Our Ref: 31530 - Chester Terrace Gardens, NW1 4ND
Camden Planning Ref: 2023/0282/P

Chester Terrace Gardens - retaining wall repair and reconstruction proposals

Proposed alternative piling arrangement, with approximate piles loads

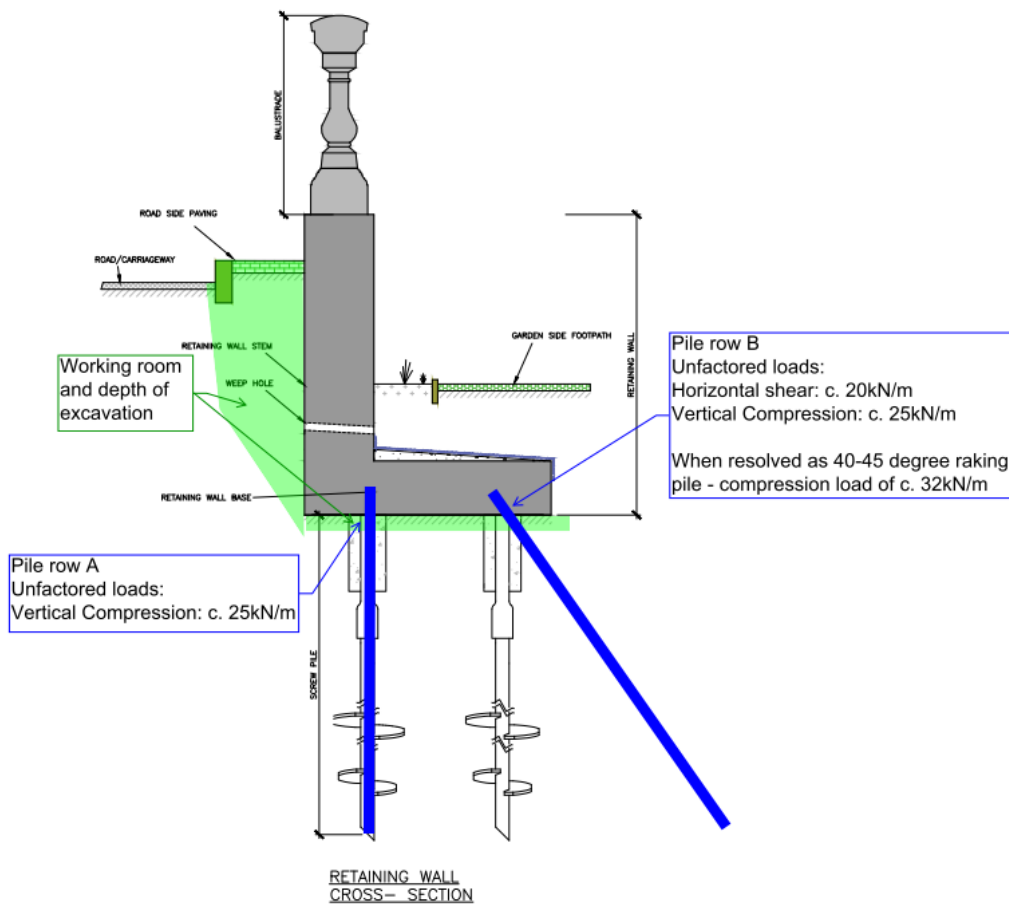
Notably, the method statement suggests that a "21 tonne excavator" is required to install the steel screw piles that will support the new L-shaped reinforced concrete (RC) retaining wall. This would presumably necessitate the destruction of all the mature trees and shrubs in the vicinity. HPM's drawings do not note the required capacities for the piles, however our own calculations show that (all loads here are unfactored) vertical compression loads of around 25kN/m, to each of the two rows of piles, and horizontal shear loads of around 20kN/m, to the outer pile row, are needed to resist the applied forces. If the outer pile row is installed at a 40-45 degree rake from vertical, resolving the forces removes the shear load and it puts the pile essentially in pure compression (and so leaves a far more structurally efficient arrangement), with a load capacity of around 32kN/m required. This arrangement is as shown in the sketch below, with proposed pile rows shown in blue.

Given that screw piles can typically be installed at approximately 500mm centre spacing before adverse group action needs to be considered, it is certainly not unreasonable to assume that screw piles could be installed at 1m centre spacing along each row. This would result in piles needing to take unfactored compression loads in the order of 25-35kN. Having spoken to some screw pile specialists, including Target Fixings (website: <https://targetfixings.co.uk/products/heli-pile/>) it is clear that piles achieving such loads in the London Clay assumed to exist on the site can readily be installed using hand held equipment, for example a 63kg pneumatic driver, and at the 45 degree rake indicated in the sketch above given the available working room. Even if the piles needed to be installed using a 1.5 tonne mini-excavator to get the required torque to reach the necessary capacity, this would still likely be possible with minimal destruction of the local mature flora. The currently proposed use of a 21 tonne excavator to install the piles therefore seems needlessly excessive, destructive, and expensive, for such modest loads that are only, after all, generated from supporting what is a relatively low level retaining wall.

Tree T214 - near Wall 2 - proposed alternative retaining wall arrangement

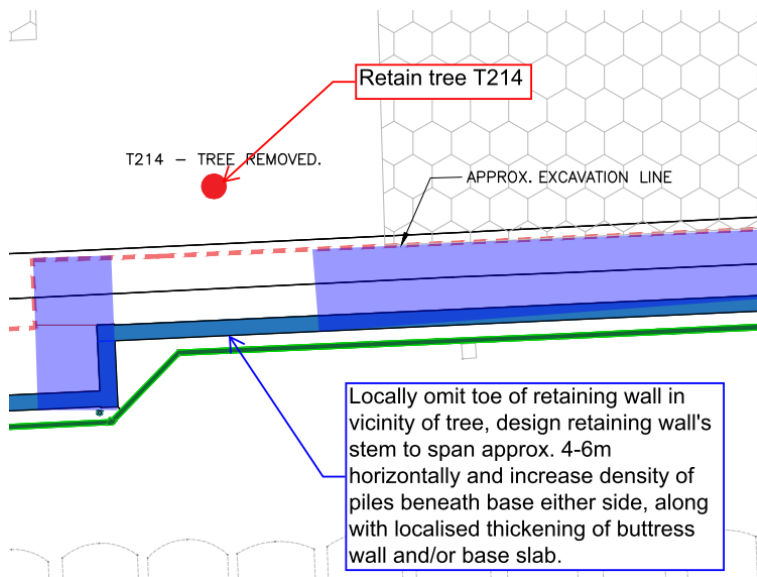
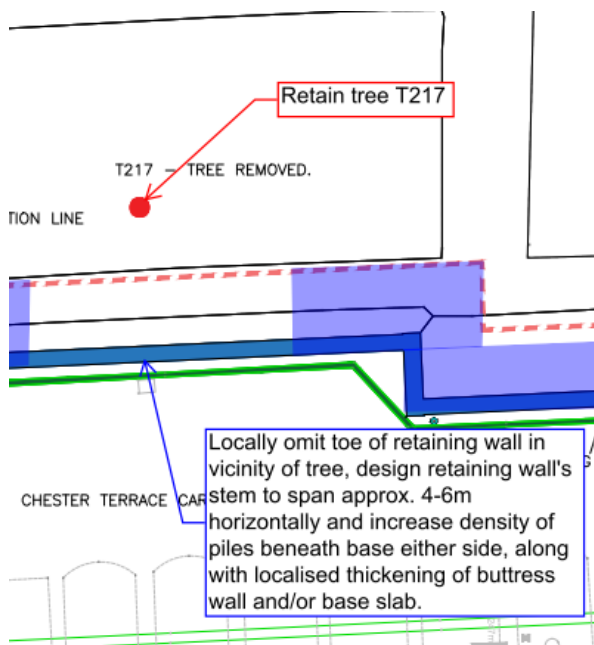
Whilst it is acknowledged that any flora immediately adjacent to where the sections of wall will be replaced will need to be removed, it does appear that an alternative structural arrangement could be pursued local to trees marked T214 and T217 and so not require their removal. Please refer to the two sketches below, which are mark ups of HPM drawing 24509-82 rev P1, showing

the basic principle. The sketches show the toe/base of the retaining wall locally being left out for a 4-6m length of wall in the vicinity of the trees, therefore meaning that the tree roots would remain relatively undisturbed. The new 450mm thick RC retaining wall stem appears to already be thick enough to span this distance horizontally, but it, or the buttressing wall and/or base at either end, could be increased in size if necessary. The density of piles beneath the toe of the retaining wall would also need to be increased at either end, but a detailed analysis of the arrangement and refinement of loads should prove it feasible.
